> Re: Remix Properties, LLC 12 Maple Avenue Site Plan Approval

RE: 12 Maple Avenue Development 12 Maple Avenue, Armonk, NY 10504

This letter is in response to comments made in the Town of North Castle Planning Department's Staff Report, dated October 2, 2023, as well as comments made by Sal Misiti from the Water & Sewer Department of Town of North Castle, dated August 23, 2023, as part of the review of 12 Maple Avenue's Application for Site Development Plan Approval. Modifications to the application's site plans and related application materials were made in response to these comments.

### The following are responses to the comments from Town of North Castle Planning Department's Staff Report dated October 2, 2023

SHEET NUMBER C-3.0

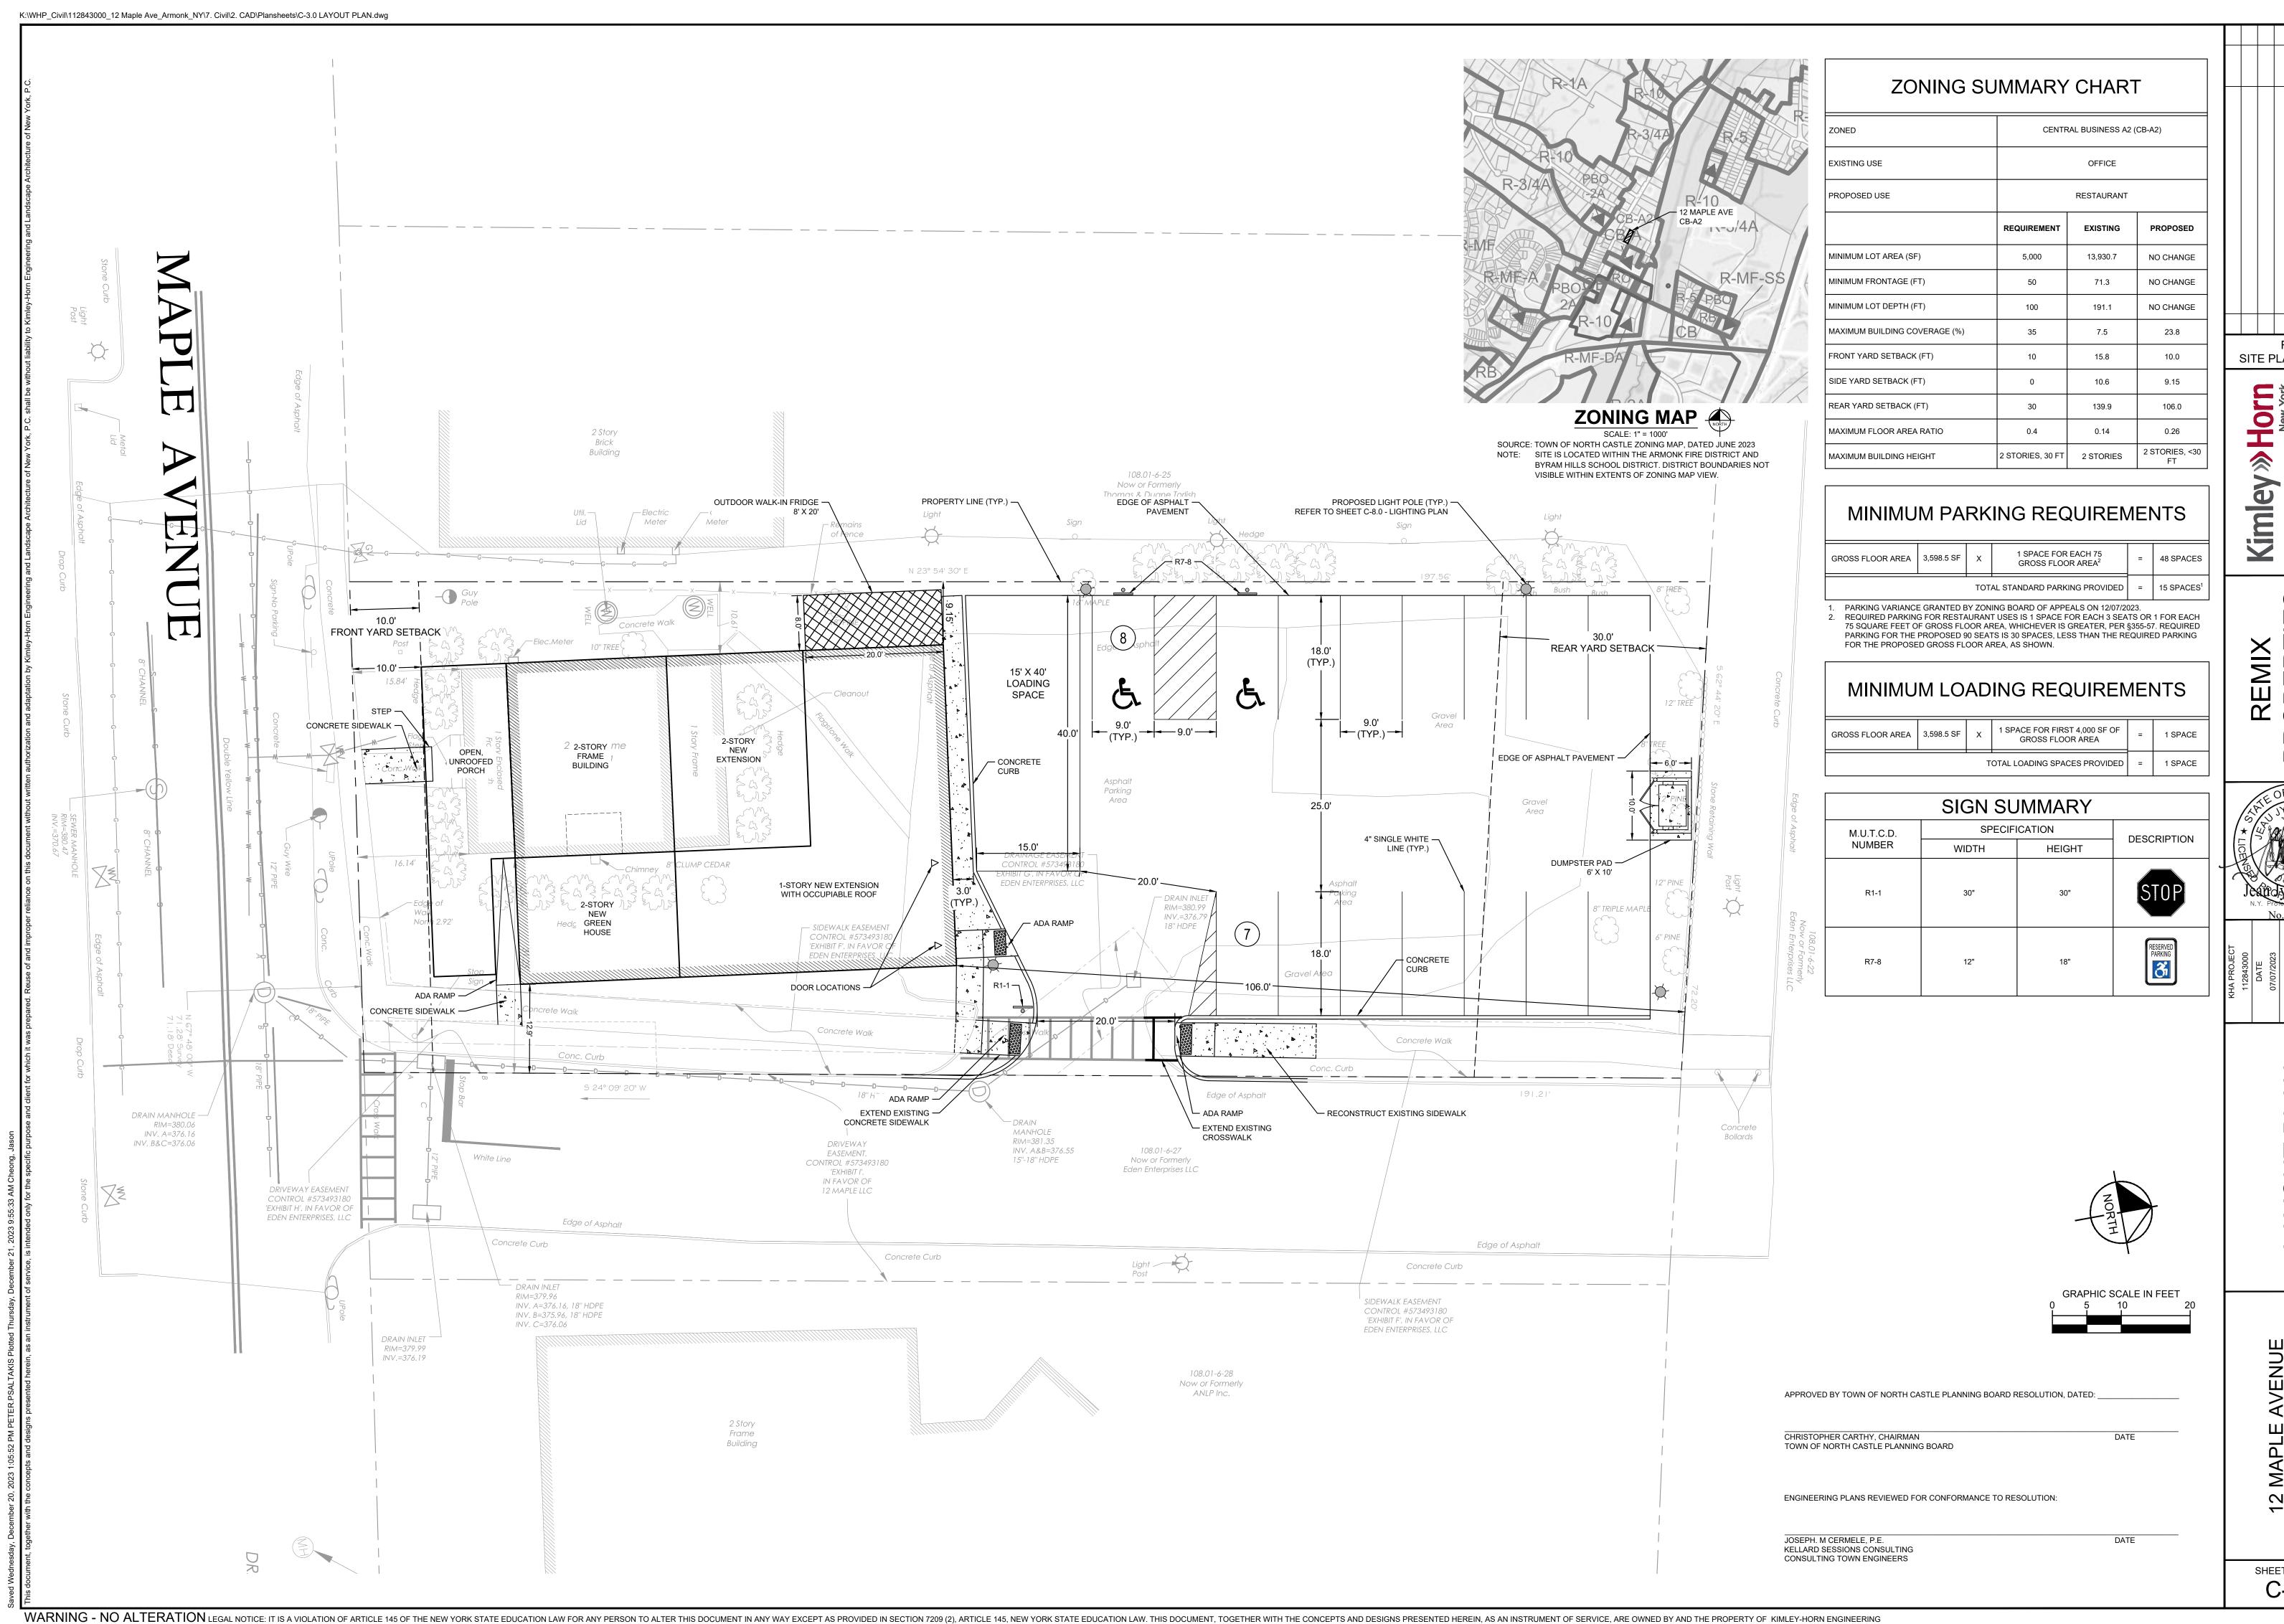
The site plan previously counted 33 seats associated with the outdoor dining terrace/bar and 21 seats on the front porch. If these areas are not enclosed, then these seats should not be counted toward the off-street parking requirement as outdoor dining does not have an off-street parking requirement associated with that

6. The site plan previously depicted ground level standing bar should be revised to assign "seats" to the locations where bar patrons will occupy the standing bar. It seems as though 8 "seats" should be assigned to this area.

Response: The seating calculation on Sheet C-3 Layout Plan has been revised, however, the required off-street parking required is unchanged due to the floor area requirement.

Response: Eight (8) chairs will be available at the ground level bar area. The patrons can freely choose to sit or stand when occupying the bar area. The eight seats have been included in the seating calculation.

# **12 Maple Ave** Section Diagram

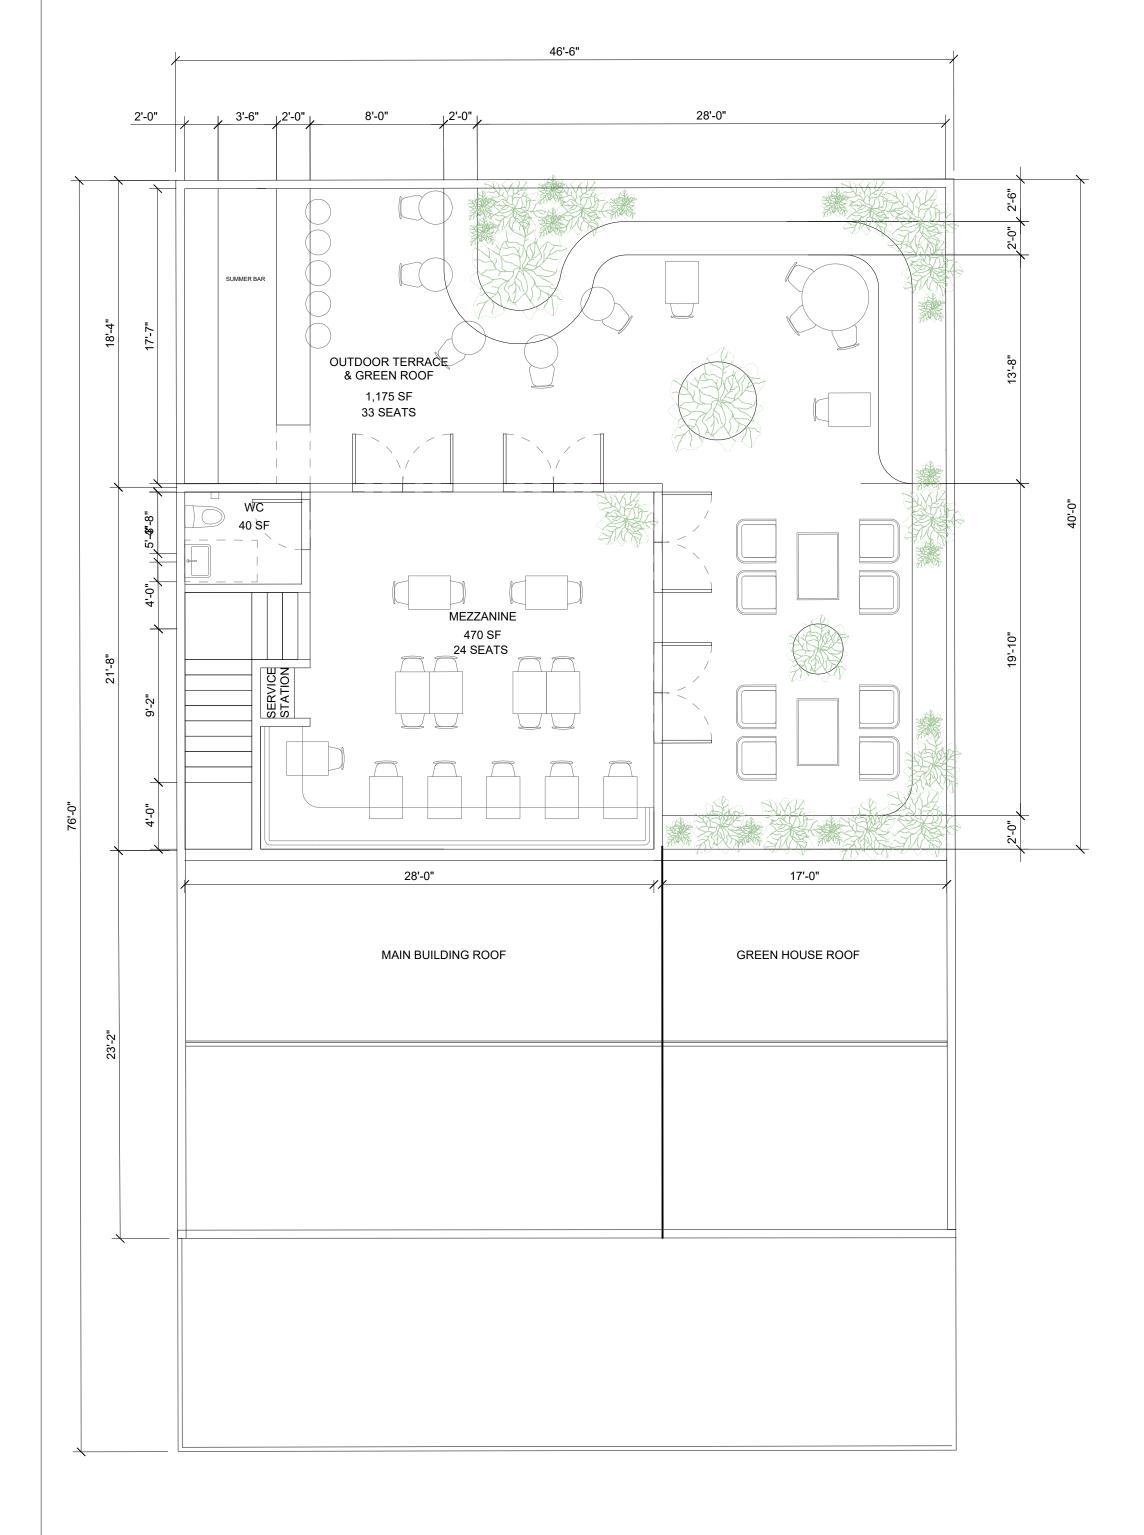
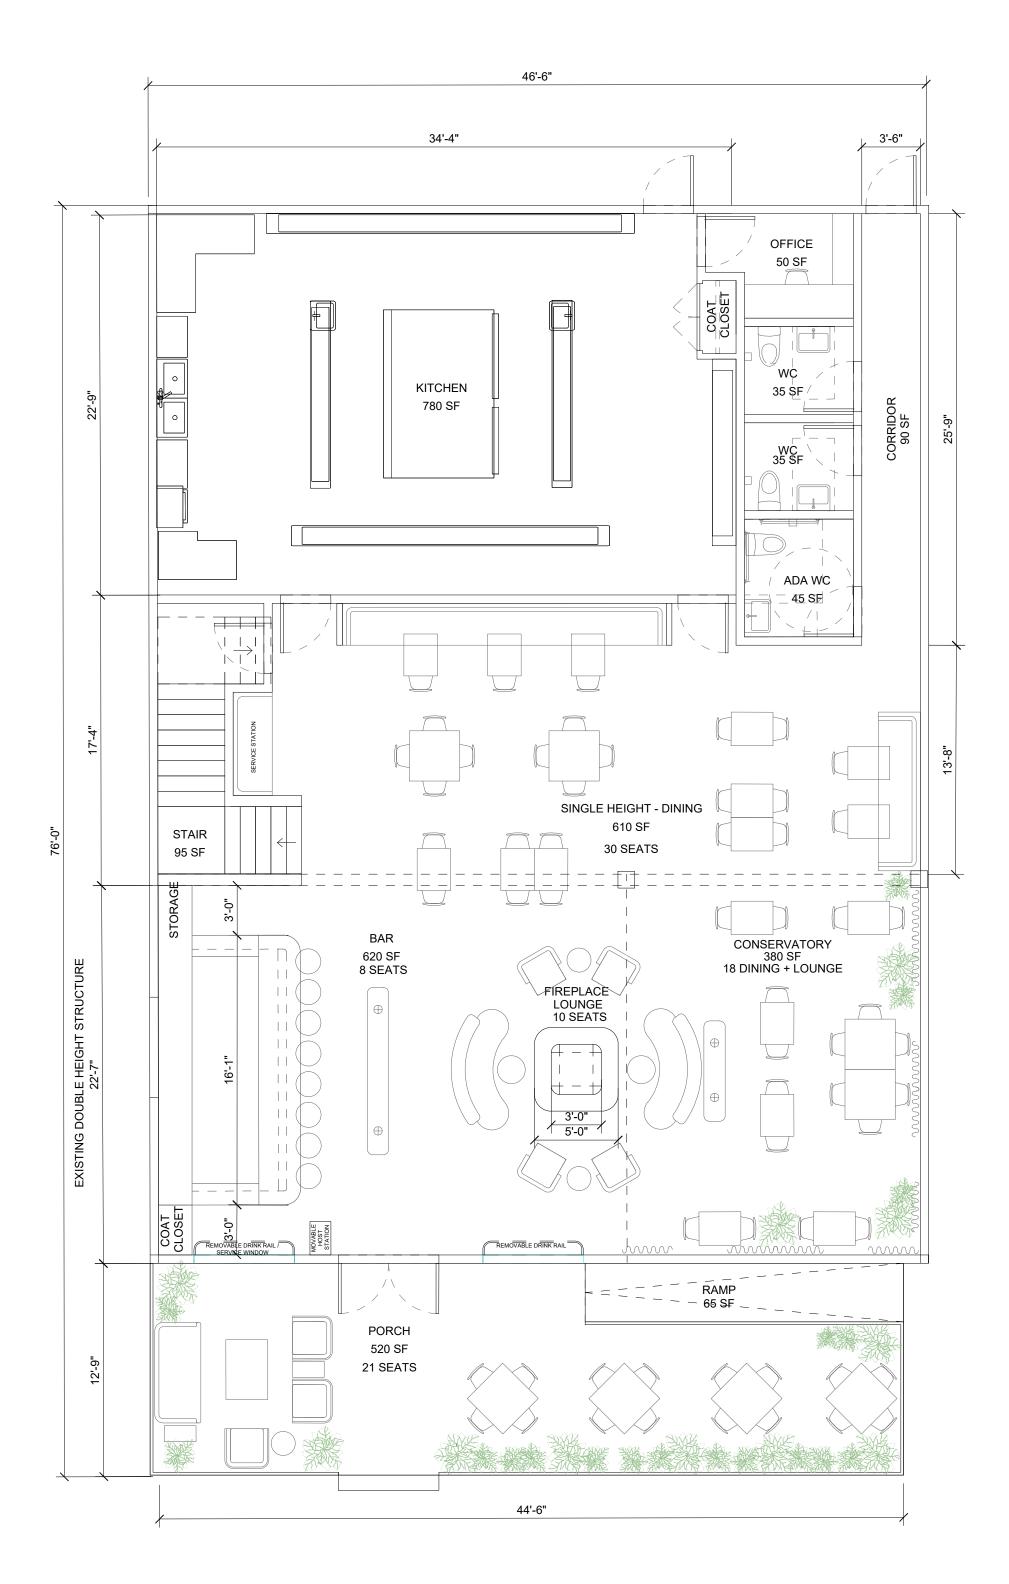
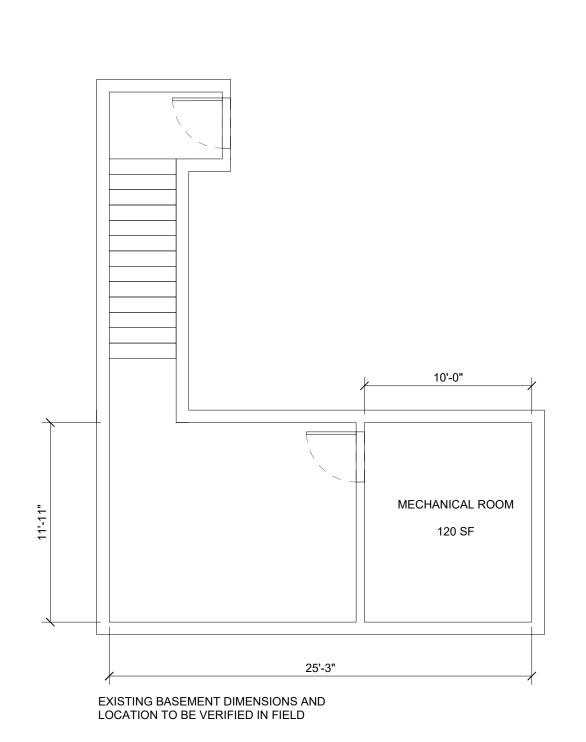
6. Understanding the utility plan provided is not for construction there is no indication for a utility area to house a water meter and the fire system backflow preventor, and appurtenances.

Response: Attached revised proposed building floor plan prepared by Fowler Design, dated 12/21/2023 depicts the basement for mechanical room to house the water meter, the fire system backflow preventor and appurtenances.
